TECHNICAL MEMORANDUM

Re: Basin 10 Drainage Review – Resident Comments and Additional Information

Date: September 15, 2026

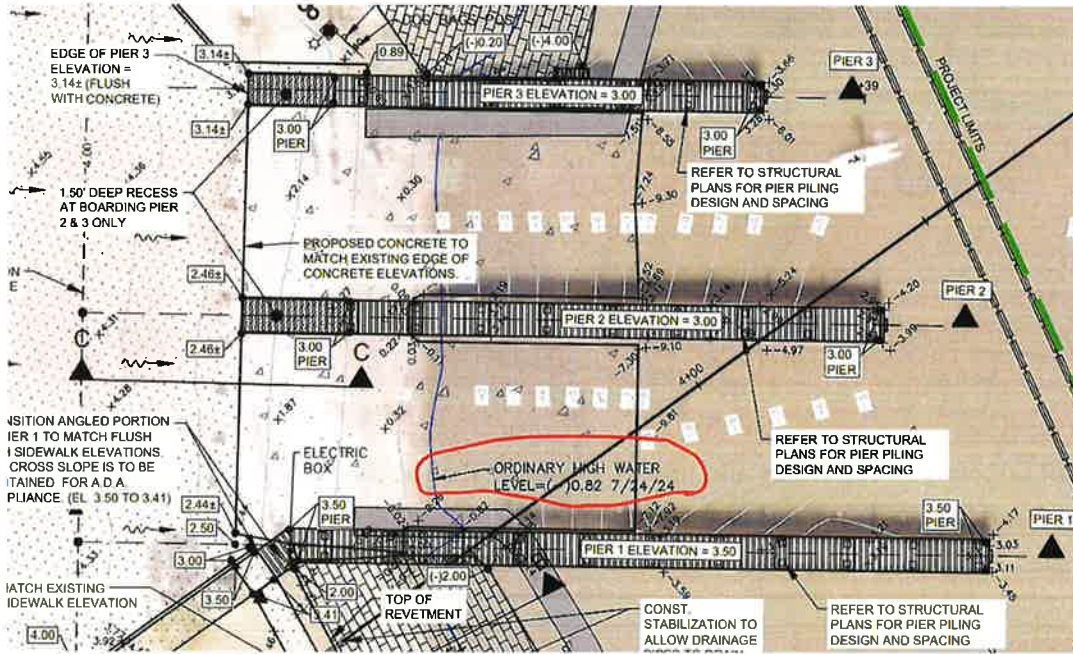
Again, based on our elevations used for the model the pipe would have about 12.5" unsubmerged on the outfall. See below from the recent field work. Everything seems to be coming back consistent at this stage.

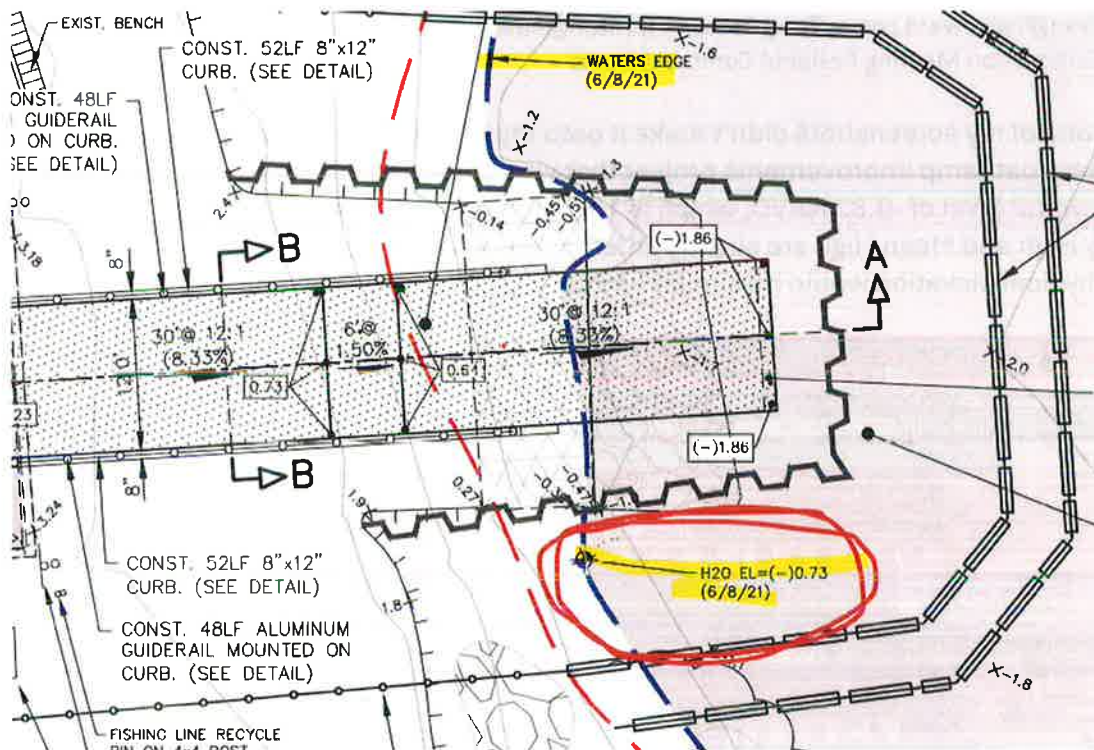
Good Morning, sorry one of my screenshots didn't make it onto my last email. Here is the City of Melbourne Front Street boat ramp improvements project that was permitted in September 2025. They note an ordinary high water level of -0.82 NAVD, which is 1.32 inches lower than our modeled tailwater of -0.71 NAVD. Ordinary High and Mean High are slightly different terms when it comes to legal/ownership but in this case the physical elevation would be similar and comparable for design purposes.

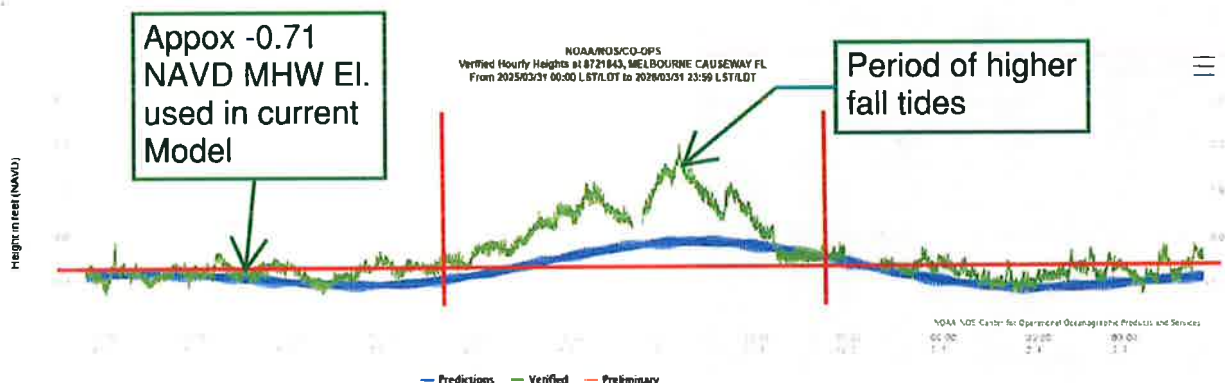
Mr Kenny made the comment that the data was outdated. This must be clarified. As defined above the mean high water elevation is what is observed over a National Tidal Datum Epoch (or NTDE). The NTDE is the specific 19-year period adopted by the National Ocean Service as the official time segment over which tide observations are taken and reduced to obtain mean values for tidal datums. It is necessary for standardization because of periodic and apparent secular trends in sea level. The present accepted NTDE is for years 1983 through 2000, NTDEs are actively considered for revision every 20-25 years. The current NTDE is now undergoing revision and will be replaced by the fifth iteration of the NTDE. Measurements for the update will be based on water level data spanning the years 2002-2020. Once all data has been collected, NOAA will review, analyze, and generate revised datums. **The current**

proposed release date for new NTDE products is in 2029. As such, we do not have any new, accepted tidal datum elevations from NOAA that we can use until 2029. And I understand the point was made to suggest perhaps higher elevations in the river persist now, or perhaps that sea level rise has substantially raised the tide in the river and may need to be considered. Fair question to ask. While not stated in our report we did look at other data sources such as a recent project by the City of Melbourne for a boat ramp facility across the river. Screen shot below showing a water level generally consistent with the mean high water elevation used in our model – this provided some more level of assurance. Additionally, in reviewing the attachment that Mr. Kenny provided, he included NOAA Tide Prediction data for the Melbourne Causeway. The data provided shows water levels generally between 0 to -1.00 NAVD, and fairly consistent with the -0.71 NAVD mean high water elevation. In Central Florida, king tides peak about 1 to 2 feet higher than normal high tides. These astronomical highs occur primarily during the fall (typically September through November) and sporadically in the spring). We can see this in the data that Mr. Kenny provided with a peak elevation close to 2.00 NAVD, see below. As previously mentioned we noted that cases like this are specific scenarios that were not analyzed for the reason mentioned above. To provide some assurance here, I did take some time to look at our model and plug in a tailwater elevation of 2.00 NAVD just to see how it could be affected. The changed in flood elevations were negligible, 1-2 Inches higher cases. This is because even at that elevation the storm system is still flowing positively. There can of course be even more extreme cases such as hurricane storm surge – and those elevations can be so high that the pipe sizes, # of inlets, etc have no impacts because the flooding is entirely dictated by the storm surge. That's not what is routinely observed and as such I support the application of our mean high water elevation in the current model to more accurately understand the regular level of service of the system.

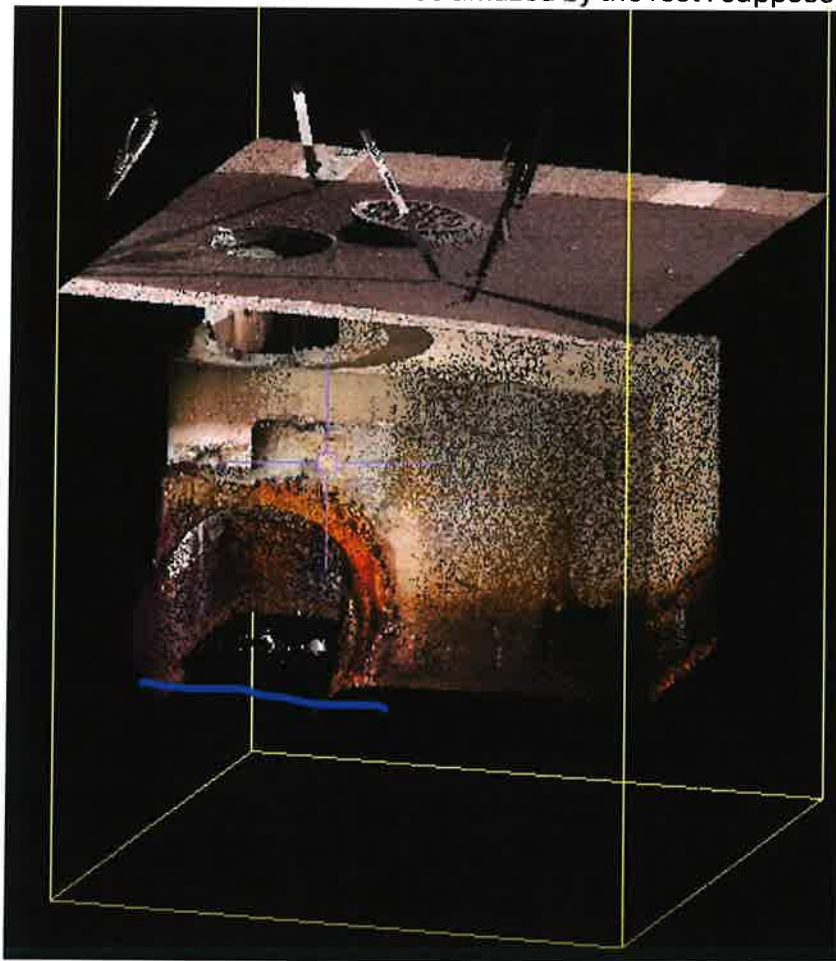
I believe tied to the tidal datum/tailwater discussion was the question of – How did Melby the manatee make it up into the storm sewer if the water levels are as low as the NOAA tidal datum suggests? While I cannot attest to seeing what Melby did myself, I have some data that shows consistency with what we have provided in our model in terms of water levels. We have recently acquired some new technology that allows us to create 3D scans of underground structures. We did not have this in March when we did the baseline survey. Regarding the water level in the storm sewer - the scanner shows where water is if it's filled up inside the drainage box. Below is the structure where Melby was found, the round pipe is the one heading towards the river (Harbor East outfall). The blue line I marked is the water line inside the box. When we look at the pipe invert elevation we obtained and the difference to the NOAA mean high water line we utilized (-0.71) you would expect water standing at the bottom of that pipe. So when we actually

scanned the structure we have a 42" pipe and there is less than 7.5" of standing water at the bottom of the pipe. Consistent with what we modeled. Bottom of the box is -1.55 so that would be about 10" of standing water in the box. This appears close to what looks like the depth of water in the box during Melby's discovery (see below, water depth appears slightly less than thickness of Melby's tail, water level slightly over the pipe inverts). It appears there are comparable water levels between the photos during Melby's rescue as the day we scanned the box – two separate dates/observations. Additionally, the invert of the pipe at the Harbor East seawall is much lower than this box. See below input from our model – the invert is -3.17 NAVD per the data we obtained. Holding the -0.71 NAVD mean high water elevation, and the 42" pipe diameter, that would have the outfall pipe submerged 2.46' or 29.5". Leaving about 12.5" unsubmerged. Depending on the tide elevation it could be slightly higher or slightly lower. I believe this would align with what Mr Kenny has seen from the water side where the pipe is mostly submerged. And again, consistent with our model. As for Melby – I still cant answer that entirely, but can confirm there would be a mostly submerged pipe for the manatee to enter at the river and it would get shallowed as pipe runs east away from the river, with some shallow water in the boxes closer to Oak Street. We can make of that what we can and be amazed by the rest I suppose.
